# ETM ESD Low Voltage Driver and Monitor

**Revision History:**  
 V1 – Initial release  
 V2 – Removed HV monitors  
 V3 – Added vac. Feedthrough and notes  
 V4 – Added Notes and Revisions Box with associated changes  
 V5 – Fixed typos and added HPF in PI function  
 V6 – Changed noise specs (30nV->160nV) and 2Hz LPF to 1Hz/30Hz second order filters cascaded  
 V7 – 1Hz/30Hz filter is now first order. Monitoring channel will now be just a resistive divider and first order LPF to attenuate PI signal. Added quadrant selector switch for PI input. Added second sheet for ITM block diagram  
 V8 – Added details to describe binary controls and realtime monitoring channels. Added polarity selection for HV on ITM version of driver. Added Enable/disable to ESD HV Amp on ETM version  
 V9 – Changed DAC noise specifications to reflect G1401399-v2 numbers and updated the operational bias voltage causing a change in allowed output noise from 160nV/rHz to 40nV/rHz. Added another stage of pole zero to each channel. Increased dynamic range of driver stages to allow 40vp-p operation. Changed the ITM version output noise spec to be TBD until we know better.

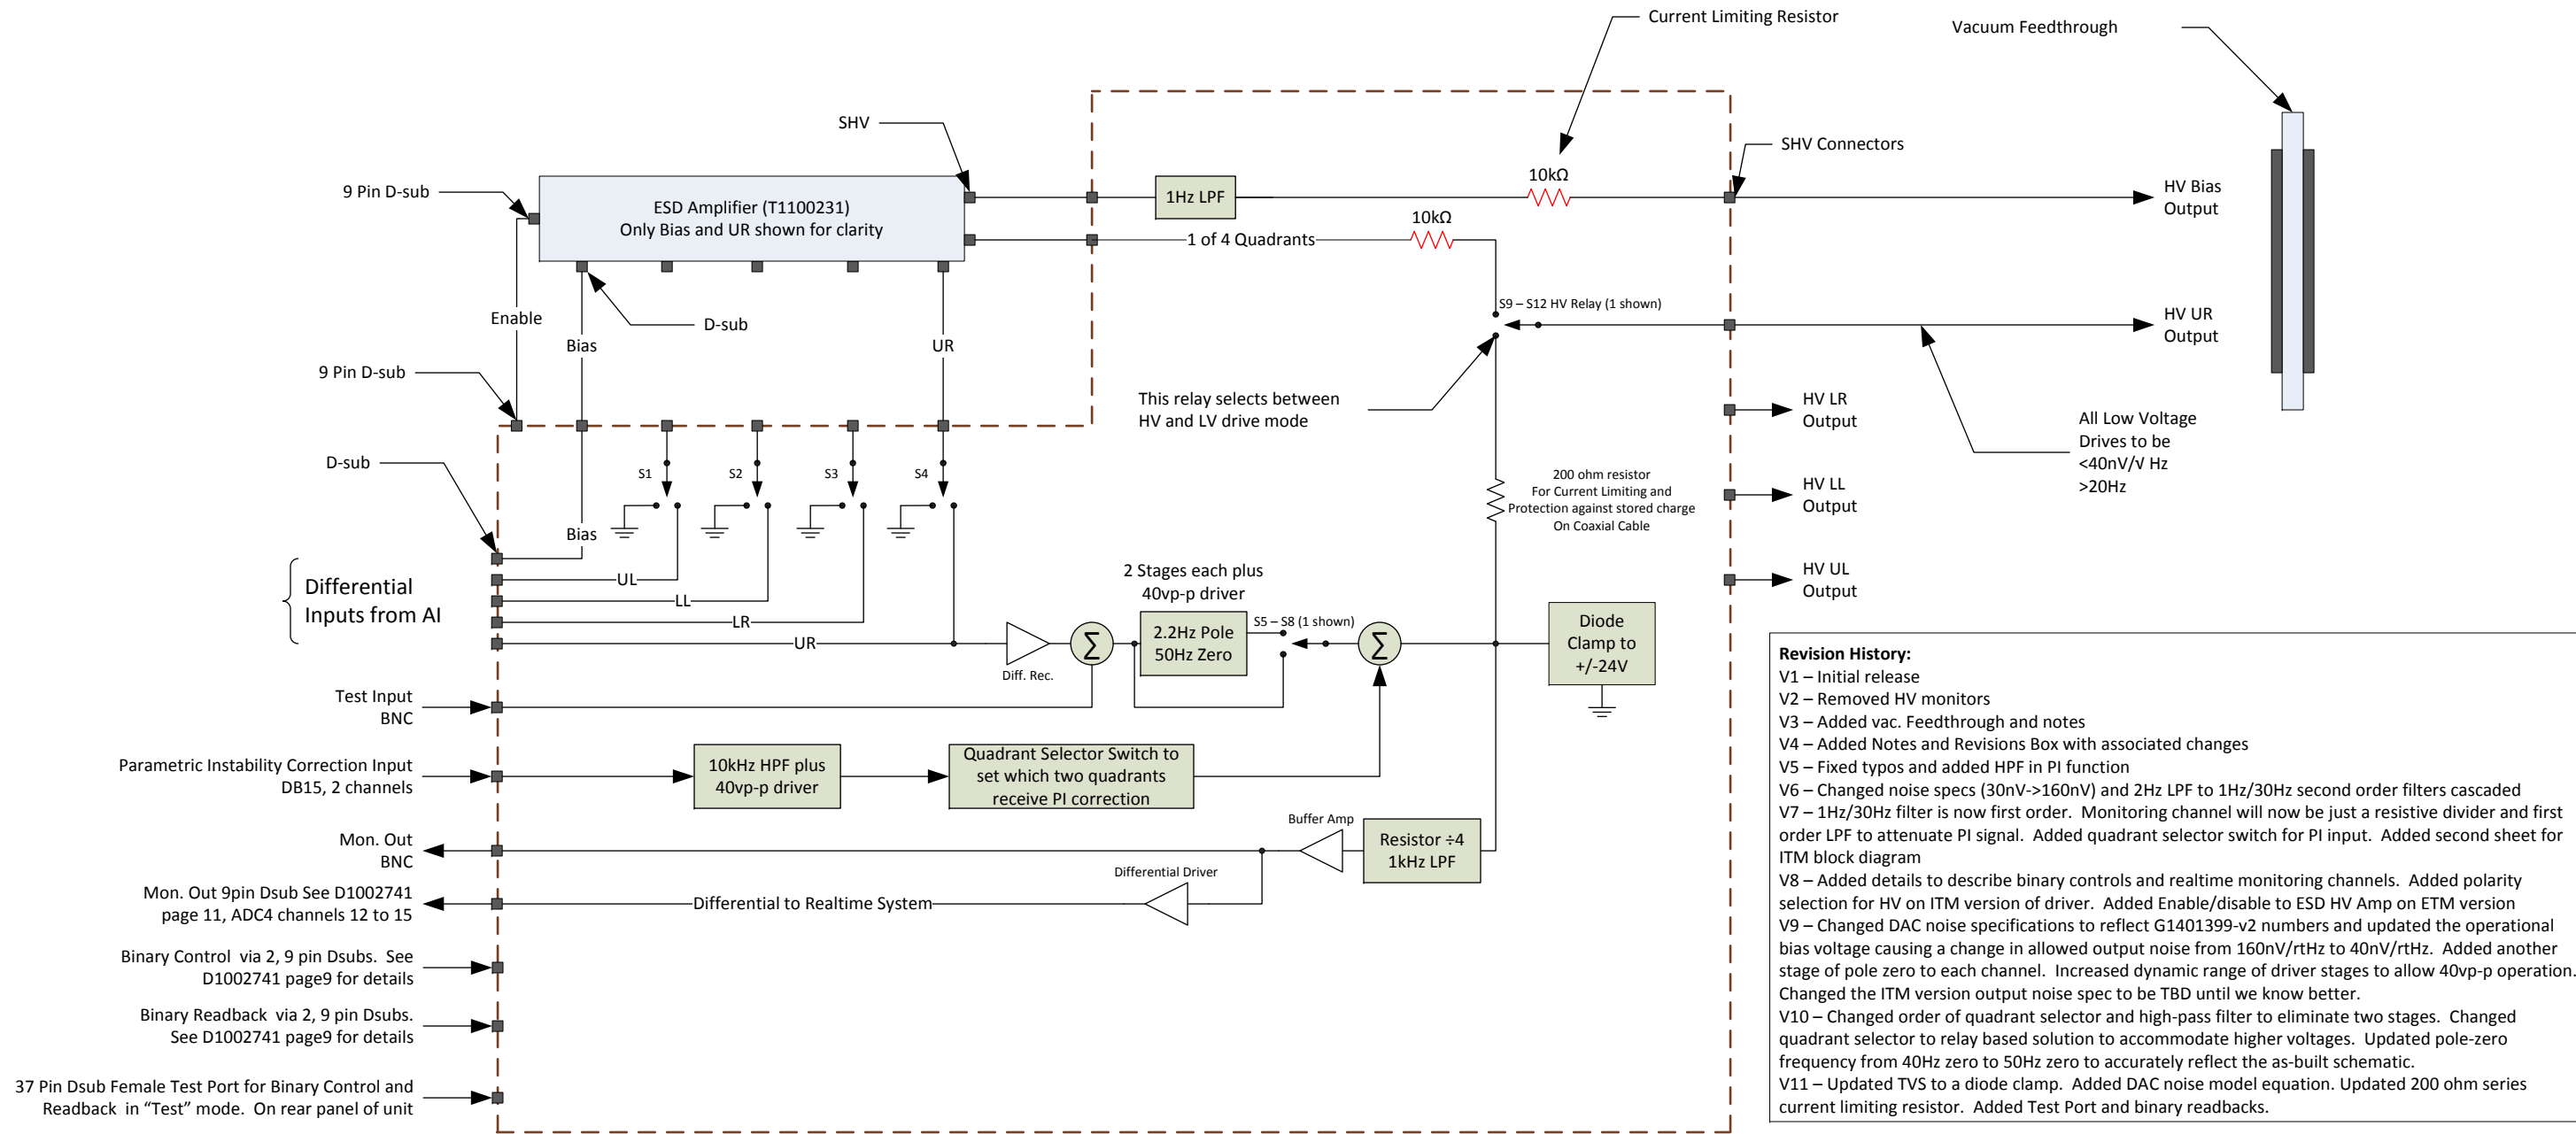
V10 – Changed order of quadrant selector and high-pass filter to eliminate two stages. Changed quadrant selector to relay based solution to accommodate higher voltages. Updated pole-zero frequency from 40Hz zero to 50Hz zero to accurately reflect the as-built schematic.  
 V11 – Updated TVS to a diode clamp. Added DAC noise model equation. Updated 200 ohm series current limiting resistor. Added Test Port and binary readbacks.
